Planning Application by David Lloyd Leisure – W/25/02787/FUL
The Valley, Twyford Gardens, Evesham WR11 4DS
Proposed Health, Fitness and Racquets Club

Response by Vale of Evesham Civic Society

Comments on two of the submitted technical reports

Google Earth Image

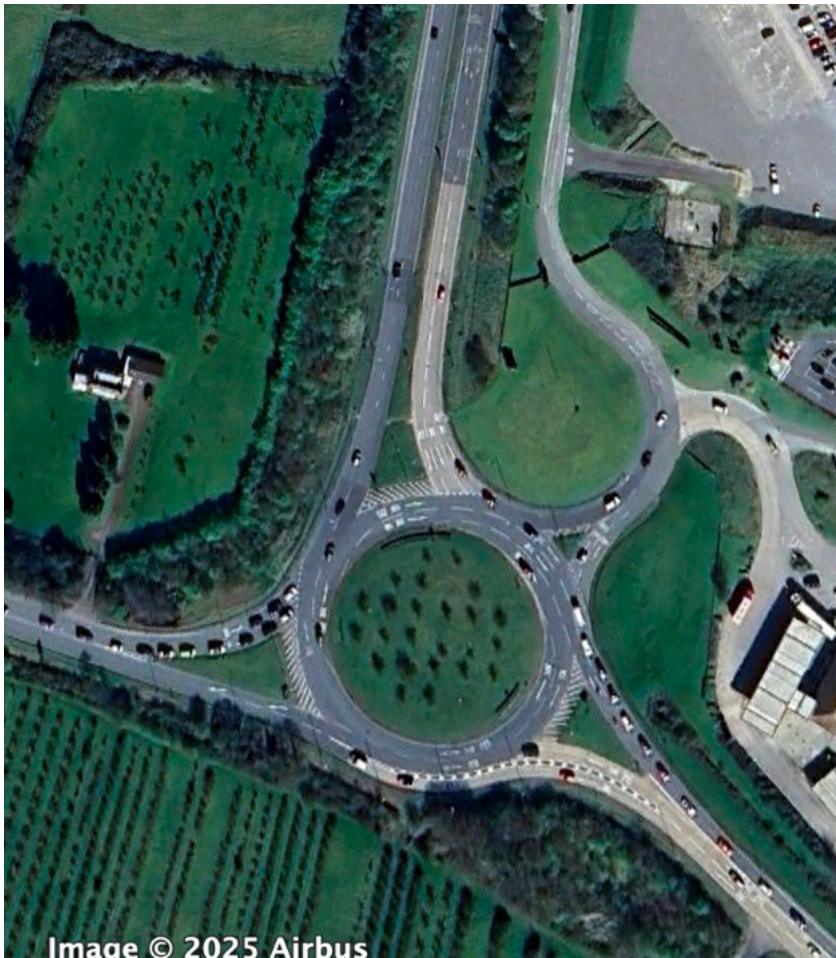
4. On the north side of the A44 a well surfaced path follows the B4088 on its west side. However, a no point is provision made for access from the footpath to link with a footpath on the east side of the B4088. It is therefore necessary to exit the footpath at the point shown on the image below and then walk south on the grass verge to a point opposite the crossing point.

- There is NO recognised and safe connection between the footpath on the west side of the B4088 and the short section on the east side.
- There is NO SAFE crossing point on the A46 dual-carriageway.
- The footpath in the north verge between the B4088 and A46 gets very close to the carriageway which in some places has been driven over by vehicles accessing the roundabout; this is a major hazard to anyone walking or cycling on this path.
- There is no cyclepath thus cyclists must use the main carriageway of the A44 and A46 which are very busy stretches of highway.
